Agenda Item: Enviro Trenchless, LLC Change Order Request No. 002 for SP189 Pipe Lining Project

Re: **Change Order Request #2**
Walnut North Centrifugal Spin Cast Concrete Pipe Lining Project

City of Dalton Public Works Department
Change Order No. 002
SP 189 - Pipe Lining Project

FIGURE
4

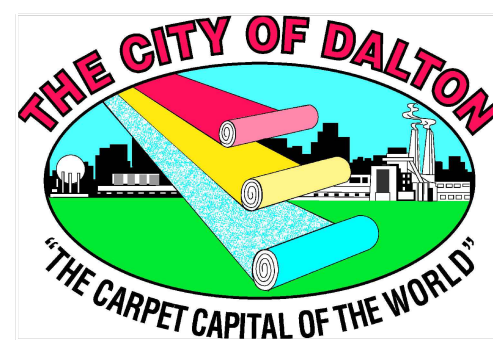
Scope of services include additional lining of a deteriorated yard inlet located in the yard of the 614 Ridge Street property that connects two pipes already being lined within the project. The yard inlet's current condition could negatively impact the finished product of the connecting pipes being lined if allowed to deteriorate further.

Description of Change: Line existing junction box/yard inlet located at 614 Ridge St. with 1/2" thickness of Madewell ML-72. The structure is approximately 7.5' L x 5' W x 5'H.

Structure Type Yard Inlet	Structure Dimensions 7.5' L x 5' W x 5' H	
Nearest Address 614 Ridge Street	Material CMU	Structure Classification Off ROW - Rigid
